V2500-A1 SERIES PROPULSION SYSTEM SERVICE BULLETIN

ENGINE – HP COMPRESSOR DISCS (STAGES 3–8) – INTRODUCTION OF A REVISED STAGE 3–8 DISC ASSEMBLY

V2500–ENG–72–0450

Family Tree - HP Compressor Stage 3 - 8 Disc Assembly
Figure 1, Sheet 1 of 2

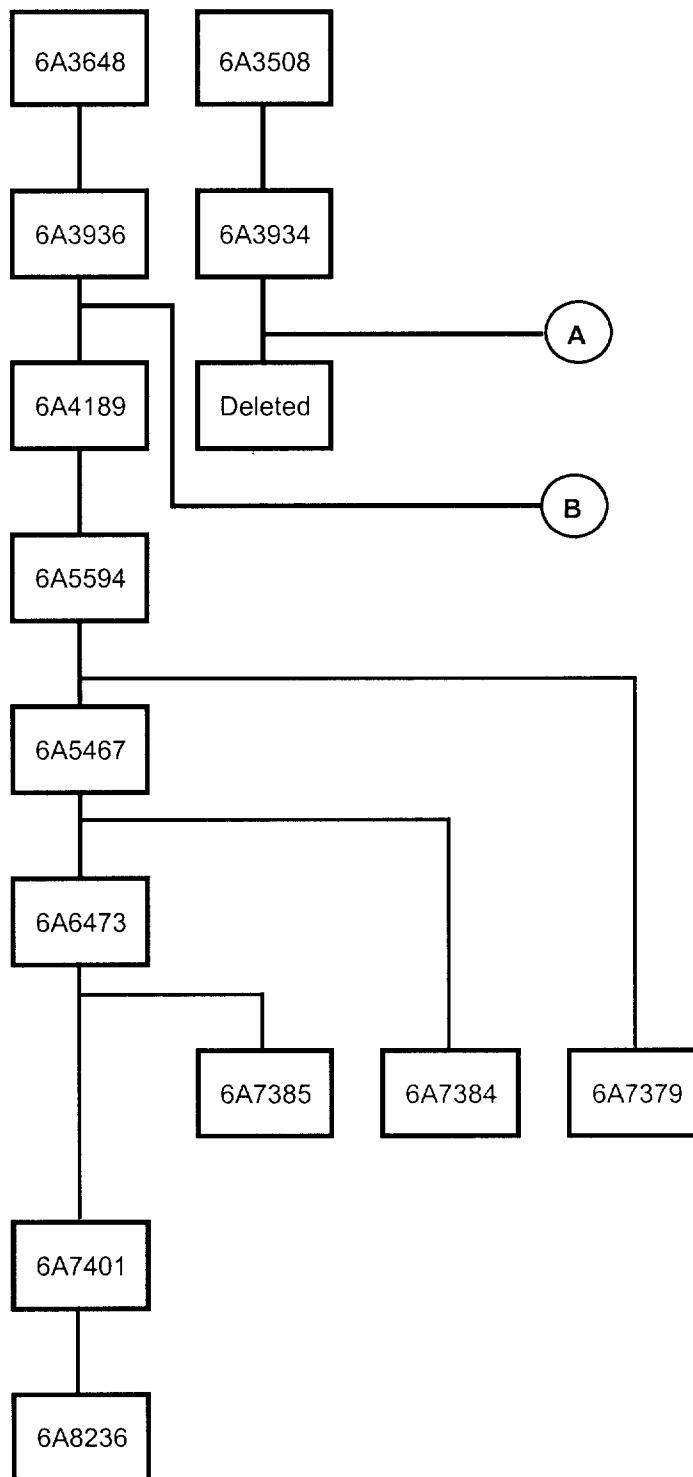
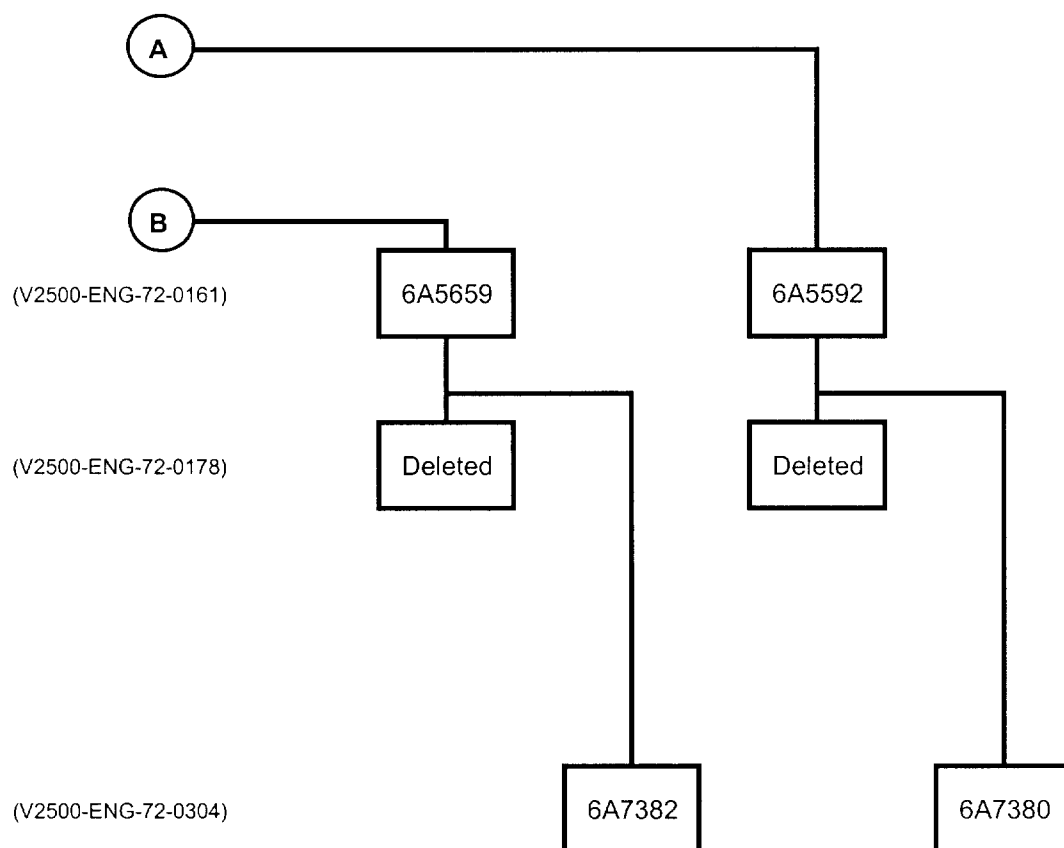
V2500-ENG-72-0450

HP Compressor Discs
Stages 3-8 - Intro of a
Revised Stage Disc Assy
